Access Compliance Report

Public Rights-of-Way

(Curb Ramps)

Intersection ID: 31651	Main Street: MAZEN_CT	Cross Street: WILLIAM_REYNOLDS_DR	Location: NE
ADA ID: 7CCB517EF116	Ramp Type: PerpDiag	Initial Pass/Fail: Fail	Overall Compliance: No
Severity Score: 8.75			
Codes/Mitigation Info/Possible Solution		Field Measurements/Component Compliance

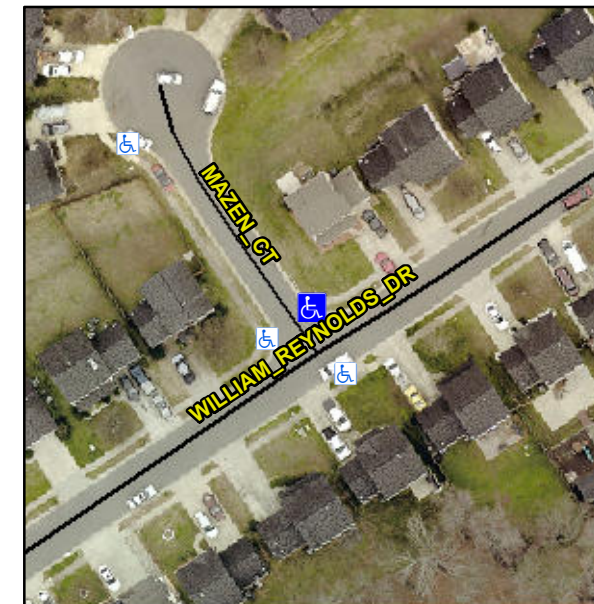
Not Found, R304.5.1

Compliance	Description	Data	Compliance	Description	Data
N/A	Ramp Length (in)	49.0	Yes	Ramp Slope (%)	6.0
No	Ramp Width (in)	47.5	Yes	Ramp XSlope (%)	1.0
N/A	Flare Type LT	N/A	N/A	Flare Type RT	N/A
N/A	Flare Slope LT (%)	N/A	N/A	Flare Slope RT (%)	N/A
N/A	Flare Traversable LT?	N/A	N/A	Flare Traversable RT?	N/A
N/A	Landing Length (in)	N/A	N/A	DWS Provided?	N/A
N/A	Landing Width (in)	N/A	N/A	DWS Contrast?	N/A
N/A	Landing Slope (%)	N/A	N/A	DWS Length (in)	N/A
N/A	Landing X Slope (%)	N/A	N/A	DWS Full Width?	N/A
N/A	Landing Curb? (Y/N)	N/A	N/A	DWS Offset (in)	N/A
N/A	Shared Landing?	N/A			
N/A	Gutter Ponding?	N/A	N/A	Gutter Slope (%)	N/A
N/A	Gutter Lip Ht (in)	N/A	N/A	Gutter X Slope (%)	N/A
N/A	Painted X Walk1?	No	N/A	Painted X Walk2?	No
	X Walk 1 Direction	To SW		X Walk 2 Direction	To SE
N/A	X Walk 1 Width (in)	N/A	N/A	X Walk 2 Width (in)	N/A
	X Walk 1 Slope (%)	0.9		X Walk 2 Slope (%)	0.1
	X Walk 1 X Slope (%)	1.7		X Walk 2 X Slope (%)	0.3

N/A	Ramp inside XWalk1?	N/A	N/A	Ramp inside XWalk2?	N/A
	Road Slope (%)	1.5	N/A	Clear Space?	N/A
	Road X Slope (%)	1.8	N/A	Clear Space to XWalk (in)	N/A
N/A	Any Obstructions?	N/A	N/A	Storm Grate/Utility Hazard?	N/A
	Obstruction Type			Storm Grate/Utility Type	
		N/A			N/A
			Yes	Surface Condition? (G/P)	Good

Remove & Replace Curb Ramp With Two New Directional Ramps or Equivalent.
